**BEAMREACH NETWORKS, INC.
BELL SOUTH CORPORATION
VERIZON WIRELESS, INC.
WORLD COM, INC.**

*Re: Establishment of Rules and Policies for the Satellite
Digital Audio Radio Service in the 2310-2360 MHz Band;
IB Docket No. 95-91*

Response to XM Radio's Supplement to August 29, 2001 White Paper¹

Figure 17
SDARS Repeater at 200W Interference to WCS System

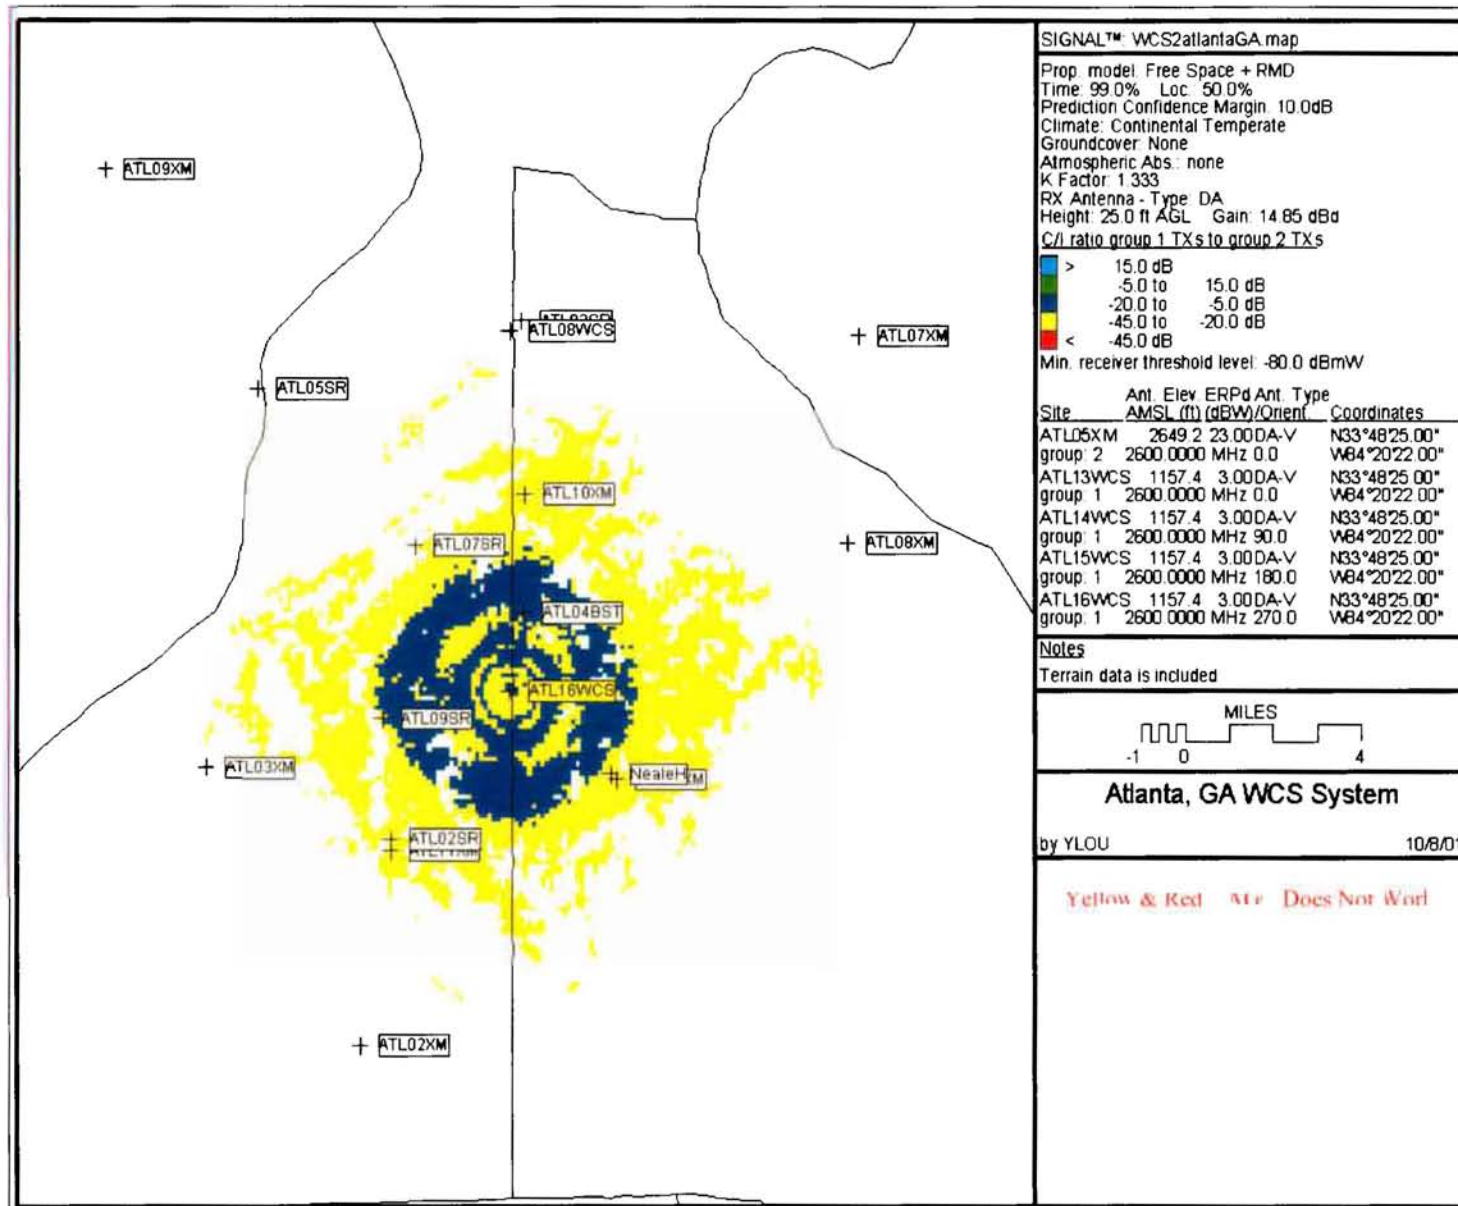
In Figure 17 the SDARS transmitter that is collocated with WCS base station ATL16WCS is turned on with an EIRP of 200 watts. This simulation again looks at the RF coverage area of WCS base station ATL16WCS. The WCS CPE in the WCS cell coverage area is equipped with RF front-end AGC. The WCS cell coverage at this SDARS EIRP is shown by the colors blue, green and bluish green. These colors represent receive levels with a power gap of 20 dB or less. The areas colored by yellow and red are the areas where AGC does not work for intermodulation interference.

Because of the inability of the AGC to mitigate the interference even at these SDARS levels, the WCS cell coverage is only spotty with *a loss in area covered of 66%*.

Figure 18
WCS Site (Collocated with ATL05XM) Coverage under Interference from All SDARS in STA

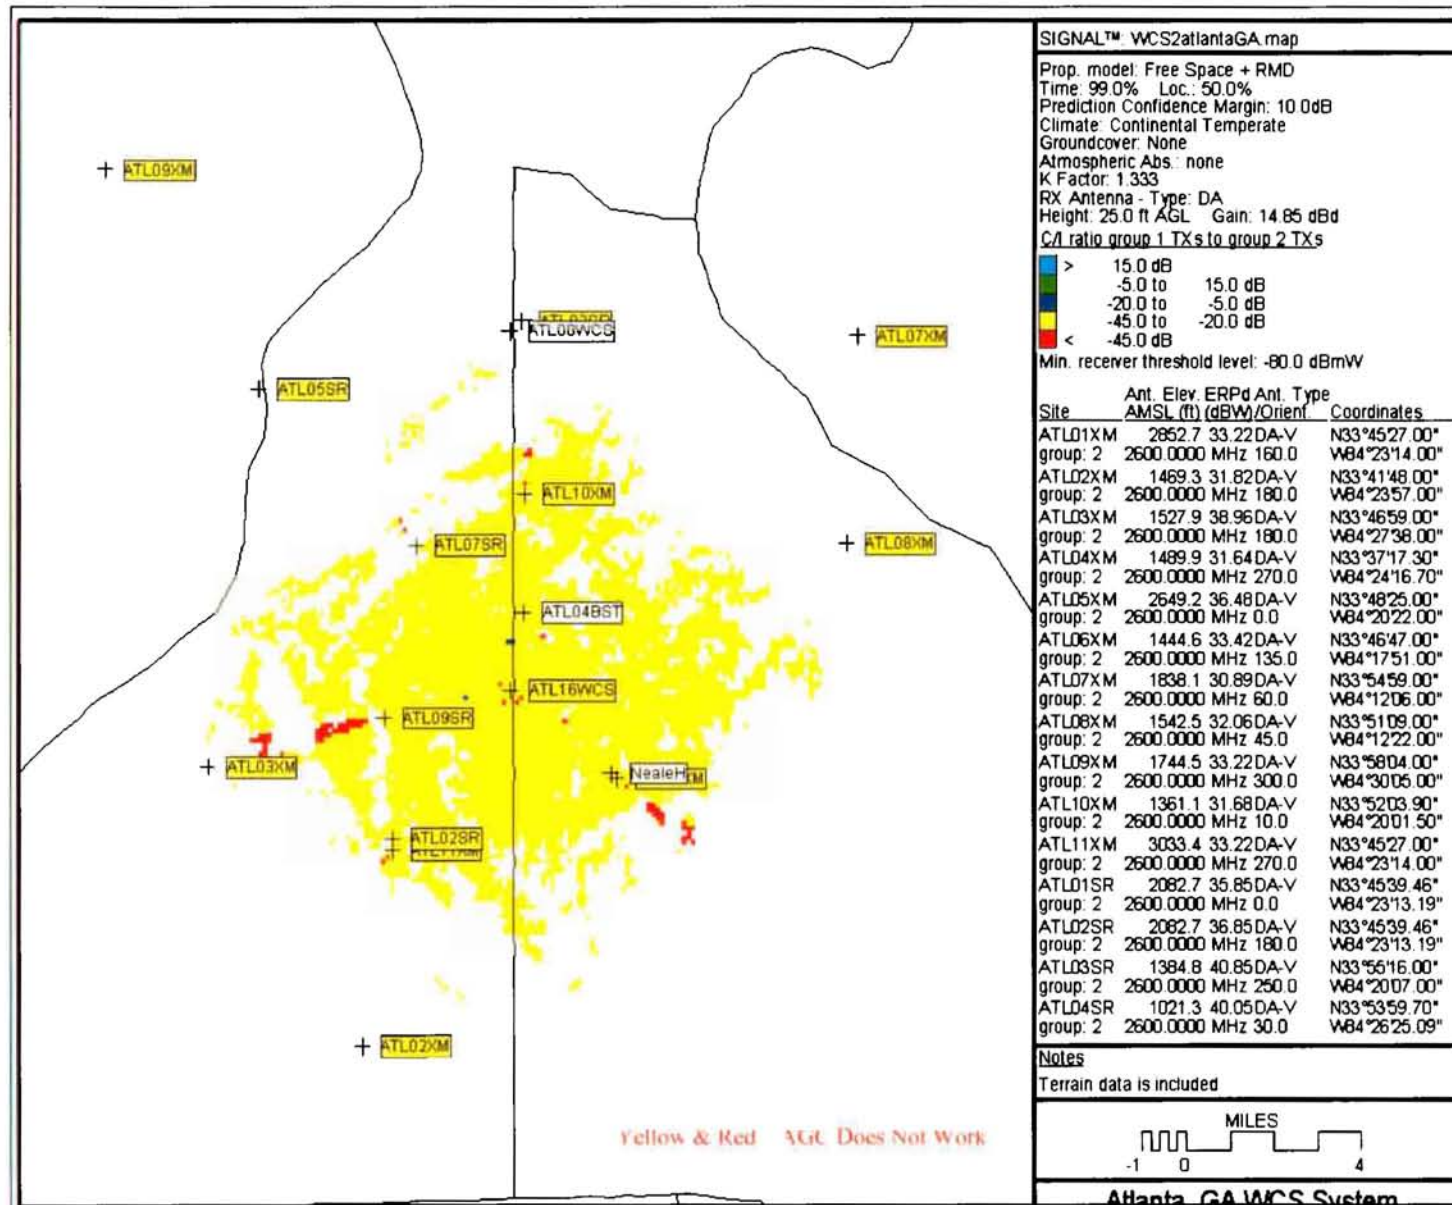
In Figure 18 all fourteen SDARS transmitters are turned. These SDARS EIRP levels are the levels stated in the SDARS licensees' STA applications. This simulation again looks at the RF coverage area of WCS base station ATL16WCS. The WCS CPE in the WCS cell coverage area is equipped with RF front-end AGC. The WCS cell coverage at these SDARS EIRPs is shown by the colors blue, green and bluish green. These colors represent receive levels with a power gap of 20 dB or less.

Figure 19
SDARS (XM & SIRIUS) Vs. WorldCom (DAL07)

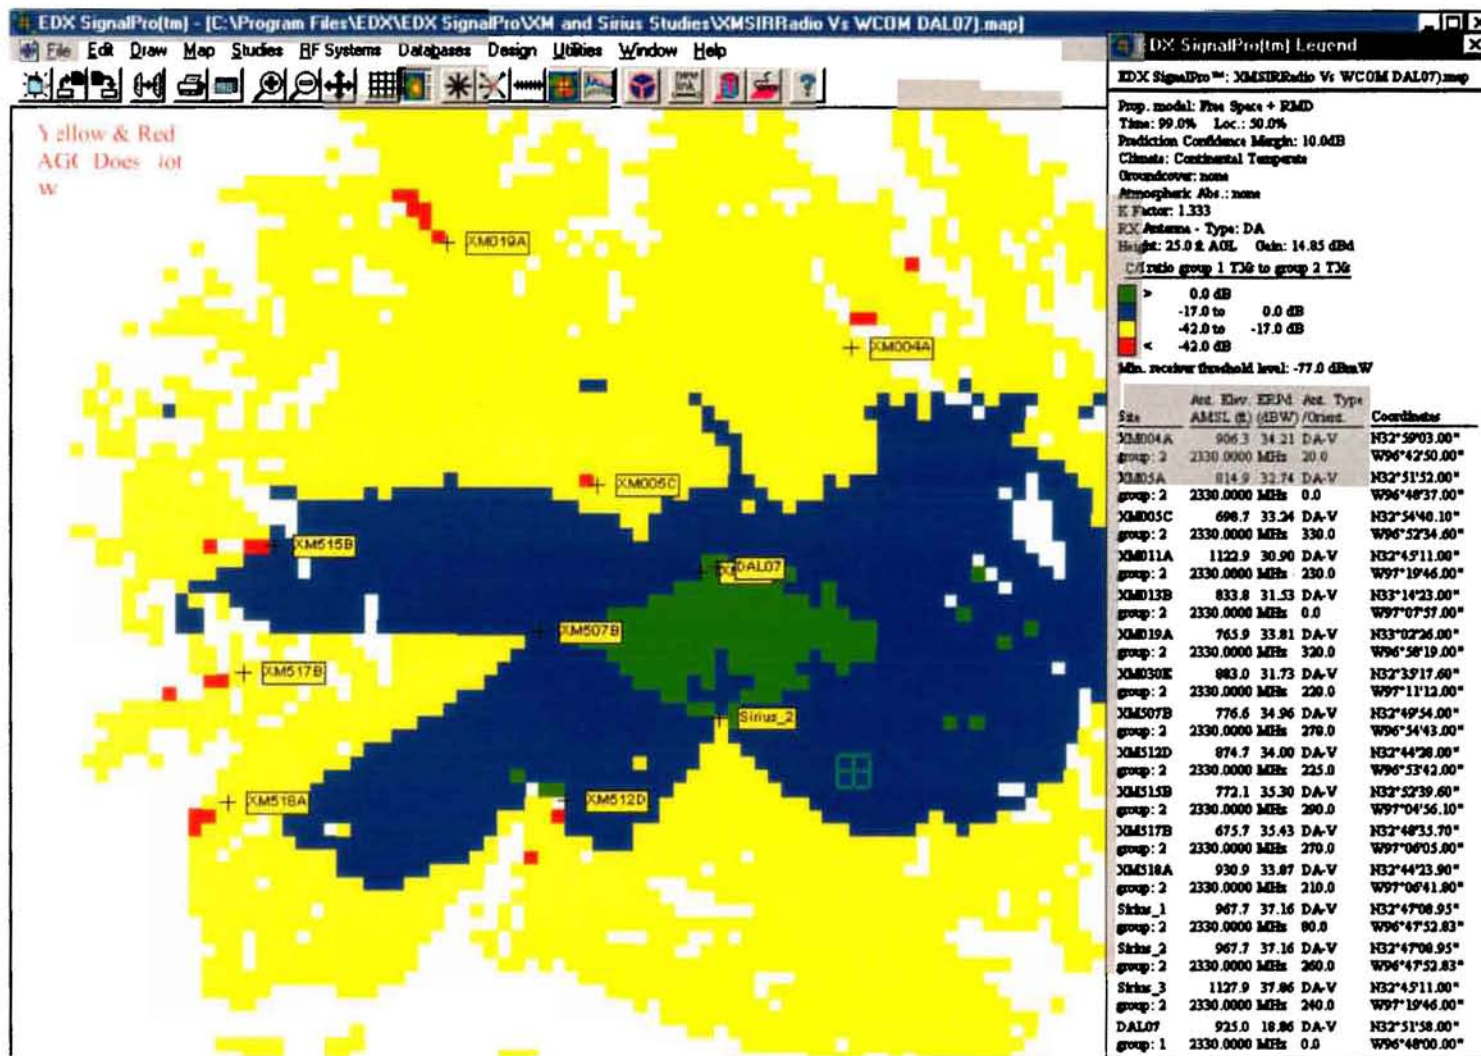
In Figure 19 the simulation looks at the RF coverage area of WCS base station DAL07. The WCS CPE in the WCS cell coverage area is equipped with RF front-end AGC.

- The colors green and blue represent areas where the receive levels have a power gap of 17 dB or less. These areas are where the WCS system with AGC could mitigate any harmful interference. The SDARS base station does not cover most of the green and blue areas.
- The areas colored by yellow are the areas where AGC does not work for intermodulation interference.
- The areas colored in red are where the AGC does not work for overload interference. There is very little red area in this figure.

Figure 20
SDARS (XM & Sirius) Vs. WorldCom (FW002)

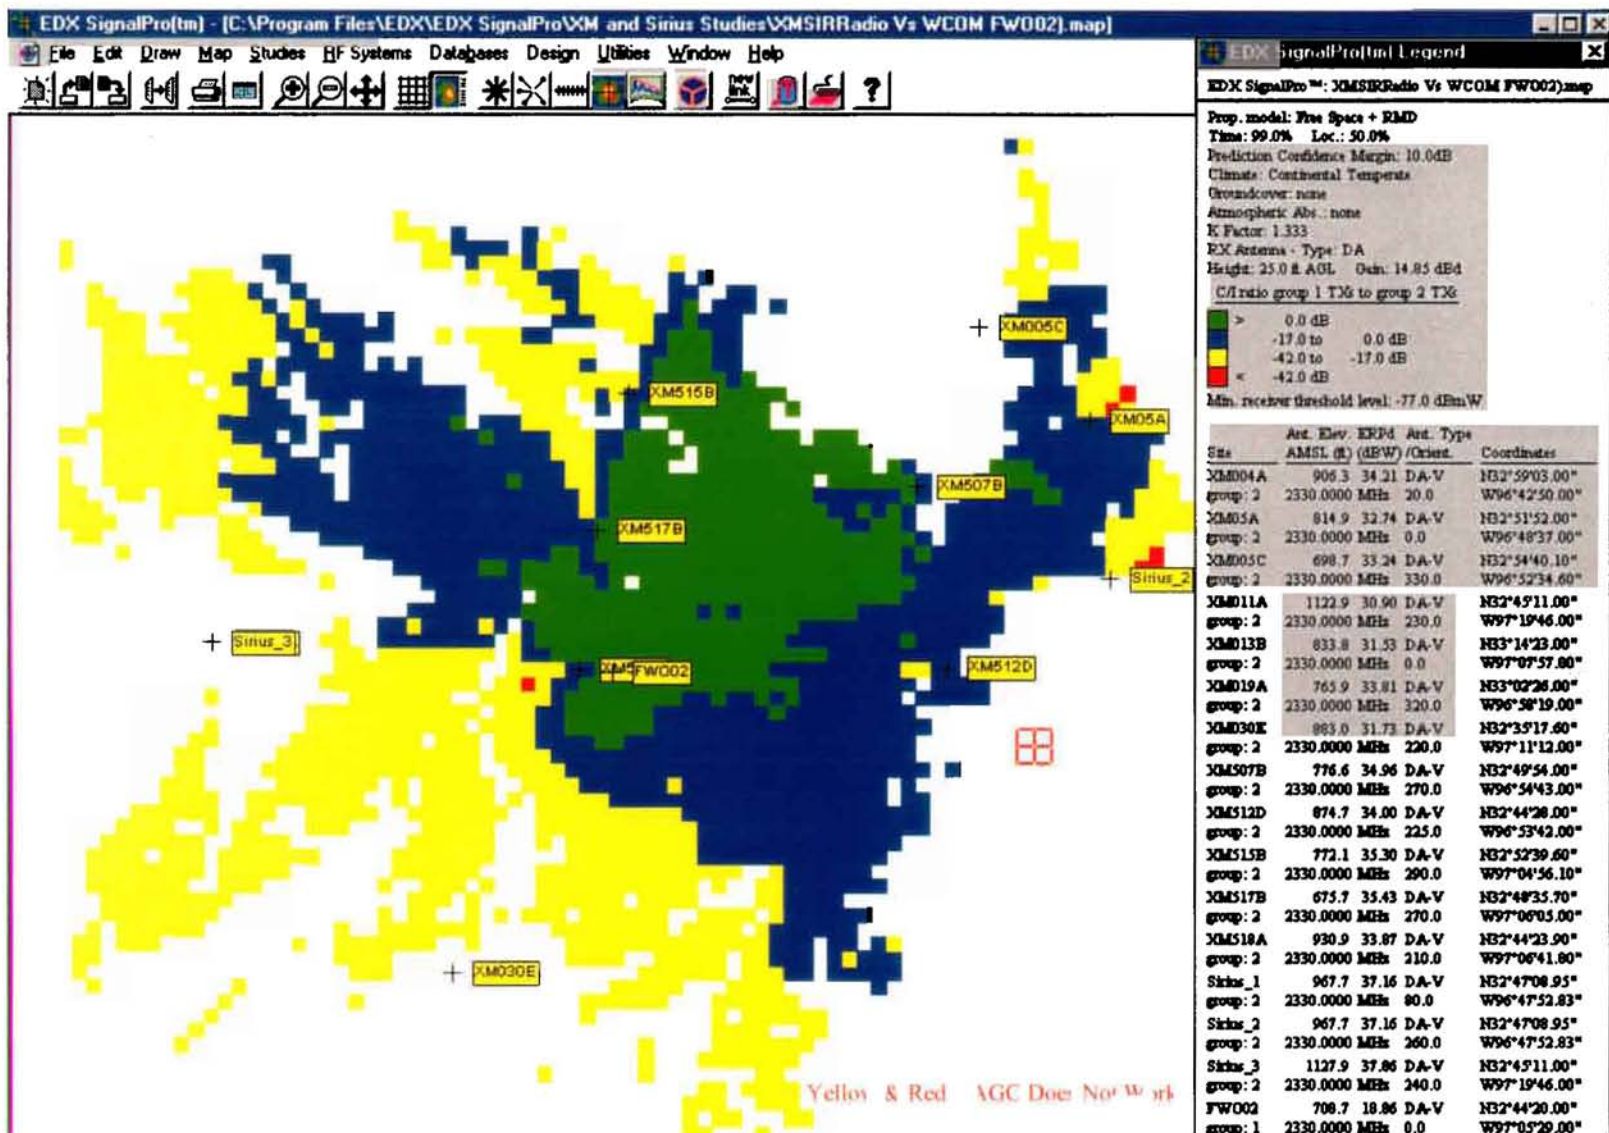
In Figure 20 the simulation looks at the RF coverage area of WCS base station FW002. The WCS CPE in the WCS cell coverage area is equipped with RF front-end AGC.

- The colors green and blue represent areas where the receive levels have a power gap of 17 dB or less. These areas are where the WCS system with AGC could mitigate any harmful interference. The SDARS base stations do not cover most of the green and blue areas.
- The areas colored by yellow are the areas where AGC does not work for intermodulation interference.
- The areas colored in red are where the AGC does not work for overload interference. There is very little red area in this figure.

Figure 21
SDARS (XM & Sirius) Vs. WorldCom (DAL08)

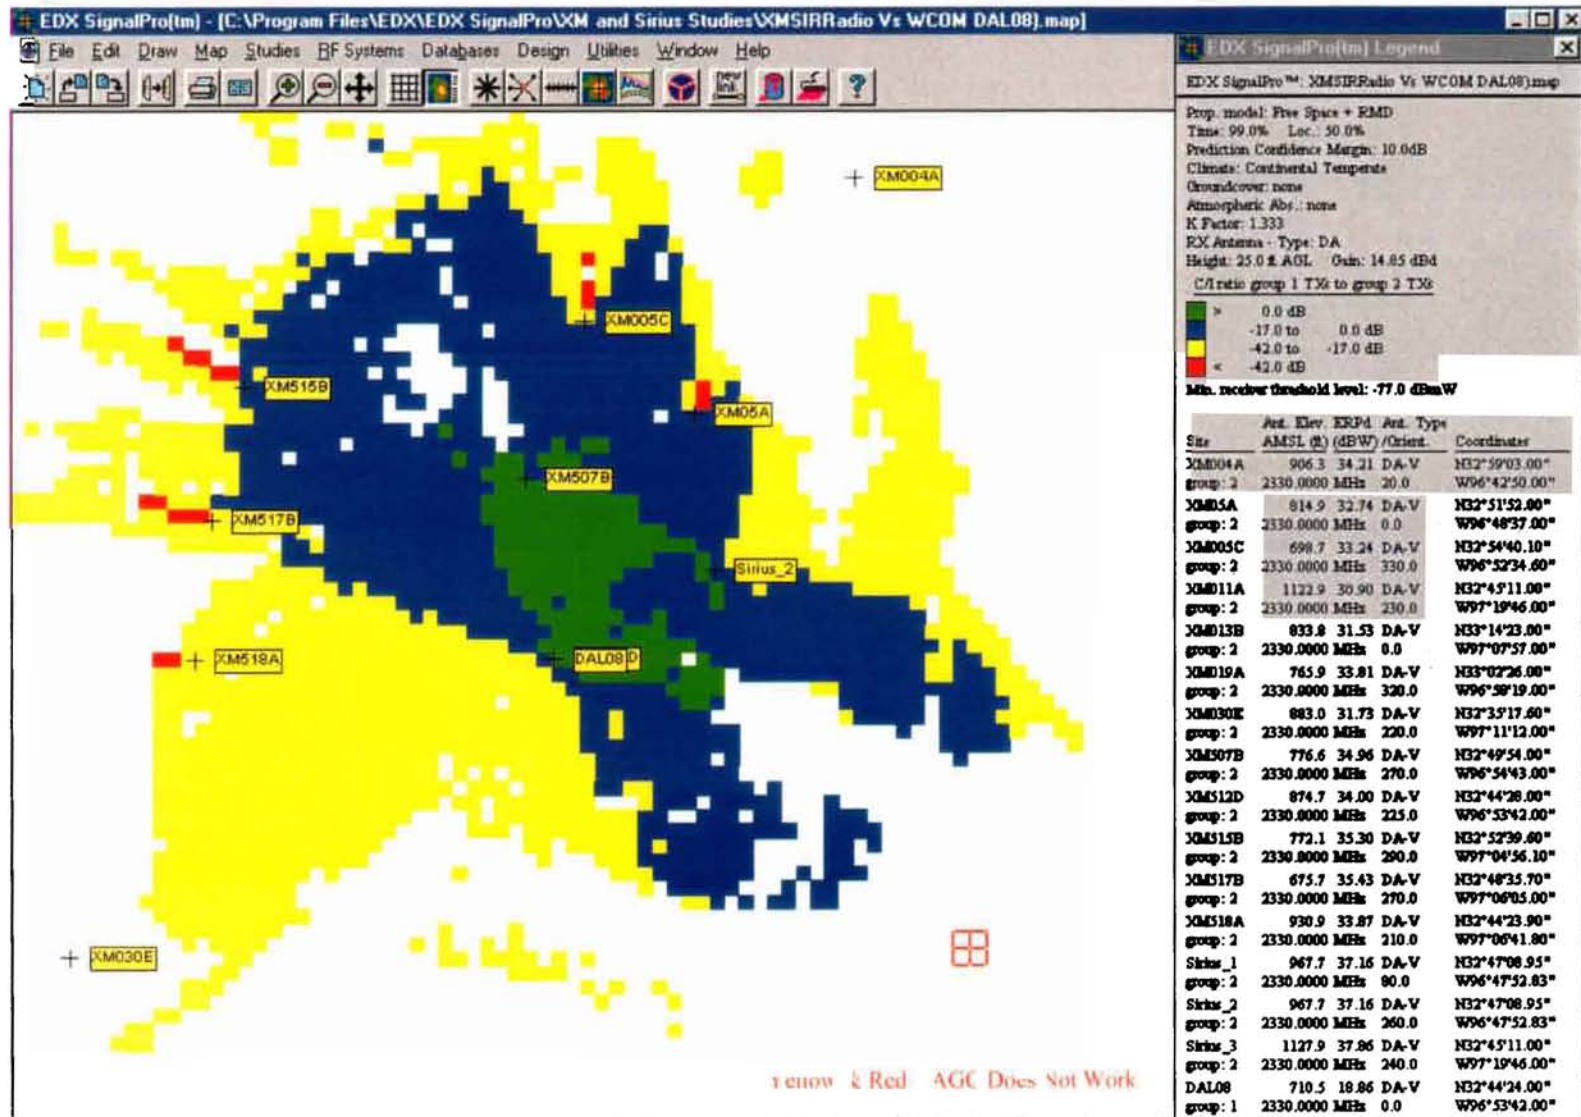
In Figure 21 simulation looks at the RF coverage area of WCS base station DAL08. The WCS CPE in the WCS cell coverage area is equipped with RF front-end AGC.

- The colors green and blue represent areas where the receive levels have a power gap of 17 dB or less. These areas are where the WCS system does not receive any harmful interference. The SDARS base station does not cover most of the green and blue areas.
- The areas colored by yellow are the areas where AGC does not work for intermodulation interference.
- The areas colored in red are where the AGC does not work for overload. There is very little red area in this figure.
